10/655,894

Takahiro Kawaguchi

Office Action Summary

DETAILED ACTION

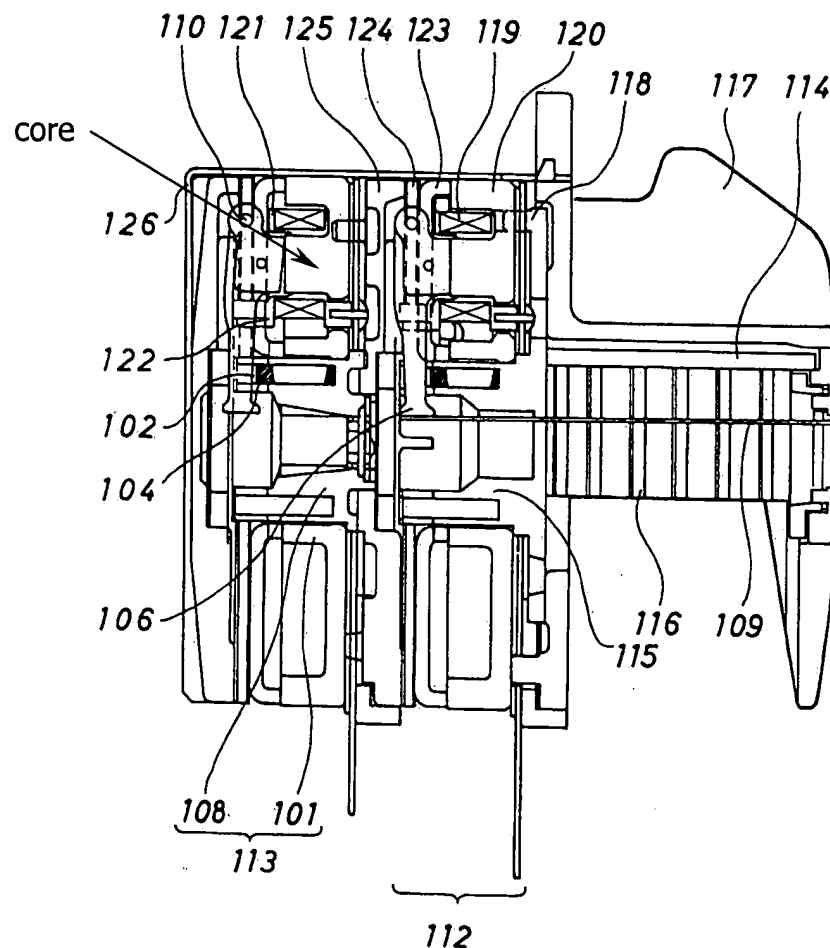
With respect to claim 1, Iinuma discloses a wire dot print head including a plurality of cores 8b each with a wound coil 6, a plurality of armatures 2 each having an arm (the leftmost portion of the armature 2) supporting a printing wire 1 and each rockably mounted opposite the plural cores as shown in Figure 1 and disclosed in the last sentence of the English abstract of Iinuma. Further disclosed are a plurality of receiving members 12a in the shape of a plate and mounted on the core side of the arm as shown in Figure 1 and a plurality of pressing members 11 each in contact with the plurality of receiving members and pressing the armatures away from the cores.

With respect to claim 4, the receiving member 12a is disposed orthogonally to the direction of pressure application by the pressing member as shown in Figure 1 of Iinuma.

第 3 図

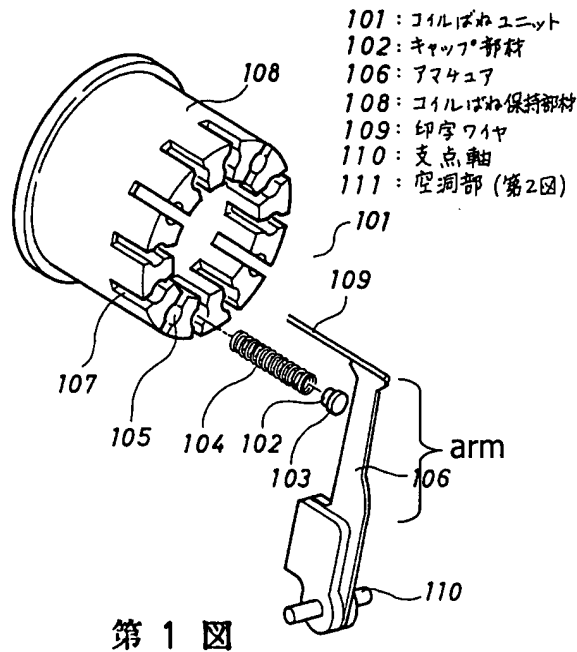
With respect to claim 1, Sato et al. discloses a wire dot print head including a plurality of cores (as shown below in the Figure 3 taken from Figure 1 of Sato et al.) each with a wound coil 119, a plurality of armatures 106 each having an arm (as shown below in the Figure 1 taken from

Sato et al.) supporting a printing wire 109 and each rockably mounted on shaft 110 opposite the plural cores as shown in Figures 1 and 3 of Sato et al. Further disclosed are a plurality of receiving members 201 (as shown in Figure 4 of Sato et al.) in which at least the top portion is in the shape of a plate and mounted on the core side of the arm as indicated by Figure 1 and a plurality of pressing members 104 each in contact with the plurality of receiving members and pressing the armatures away from the cores.

With respect to claim 5, Figure 1 of Sato et al. shows that the end face on the core side of the arm is smaller in width than the pressing member.
